PRODUCT/PROCESS CHANGE NOTICE (PCN)

PCN #: L-0607-01	DATE: 4-Aug-2006	MEANS OF DISTINGUISHING CHANGED DEVICES:
Product Affected: Please see the attached list of the affected products shipped in tape and reel and in tubes	☐ Product Mark	Lot shipments will have Level 1
Date Effective: 4-Aug-2006	☐ Back Mark	Moisture Sensitive Label, and with
	☒ Date Code	date code "0630".
	☐ Other

PCN Type: Change in Moisture Sensitivity Level

To: MSL 1 Non-Moisture Label

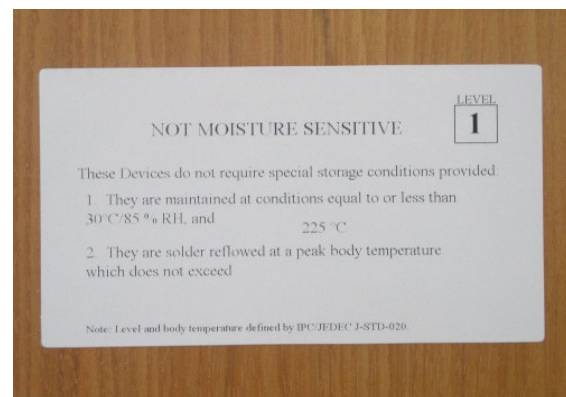
The affected products will be shipped without dry pack and labelled as MSL 1 according the JEDEC J-STD-033. There is no change to the assembly material set and the peak reflow temperature. Please refer below for the examples of moisture sensitive labels.

From: MSL 3 Moisture Sensitive Label

Note: There is no change to the peak reflow temperature of the affected products.
